# Sydney Gateway Road Project

## Major Development Plan

### Refinements and Clarifications

#### Section 1 Project refinements and clarifications

Figure 1.7 Preliminary site accesses and haulage routes

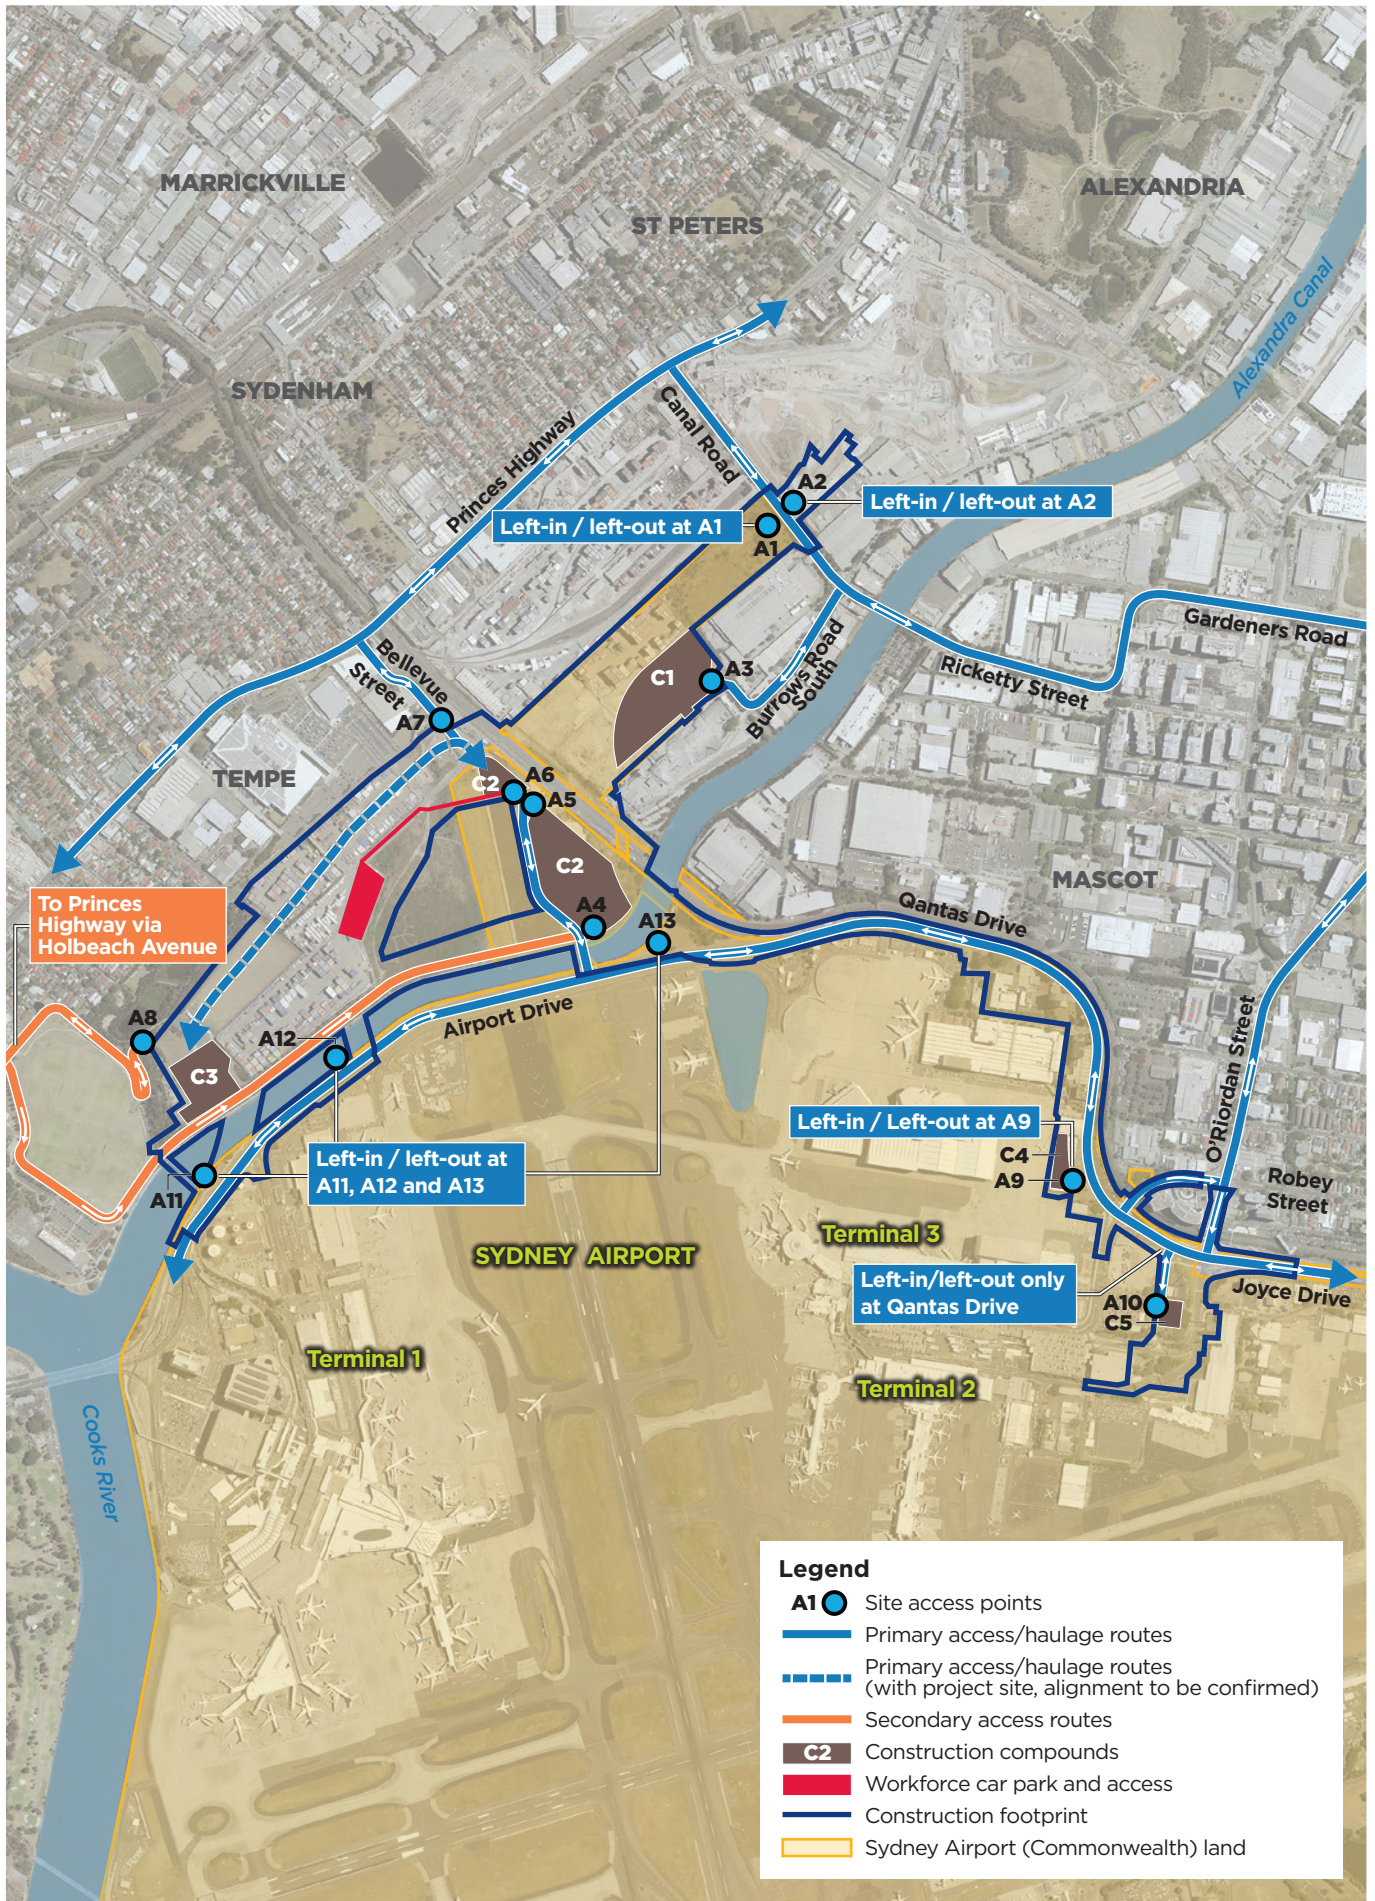
Following submissions from a number of stakeholders regarding the suitability of the proposed haulage routes, indicative traffic volumes and proposed access points, Transport has determined that Holbeach Avenue and access point A8 are no longer required to be used by heavy construction vehicles. Heavy vehicle access to the western bridges compound and work areas would be via access points A4, A5, A6 and A7 (see Figure 1.7). Further review of the proposed construction traffic using access point A8 has also resulted in a revision of the estimated light vehicle movements during the peak periods.

Further refinement of the earthworks quantities has resulted in a reduction of the number of vehicles required for the importation of fill. As a result, the required number of vehicle movements to import fill have reduced to 9,800 from 10,200.

Also, as described in section 1.1.2 of this report, the number of truck movements required to transfer landfill waste to off-site disposal locations has increased. Table 1.4 provides the updated construction traffic volumes required for earthworks activities including these two changes (underlined and in bold font).

Figure 1.8 Changes to impacts on advertising structures

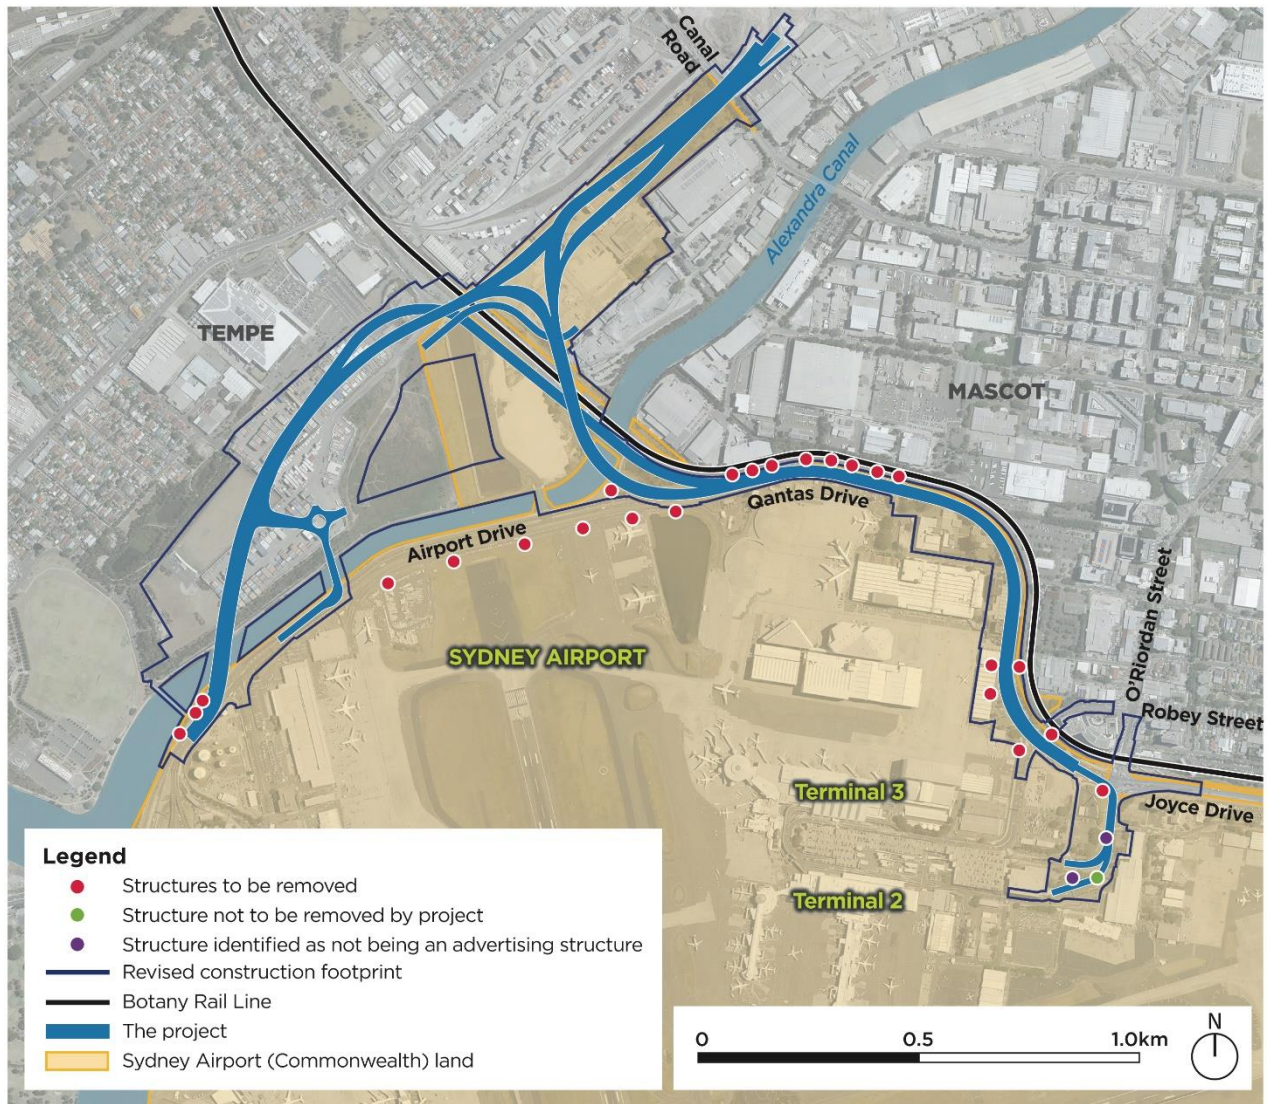
As described in section 19.3.3 of the EIS/MDP, the project would require some structures to be removed. Since exhibition, further work has been undertaken to minimise impacts on advertising structures. As a result of these further investigations, it is confirmed that the project would result in direct impacts (ie removal) of 24 advertising structures. This is three less structures than proposed in the EIS/MDP. The change in impacts is a result of the following:

- Avoiding a structure located adjacent to Sir Reginald Ansett Drive (see Figure 1.8)
- Confirming that two structures initially identified as advertising structures are currently used for wayfinding signage. The location of these two structures are shown on Figure 1.8.

The resulting impacts on advertising structures by the project would reduce from 27 to 24 structures.
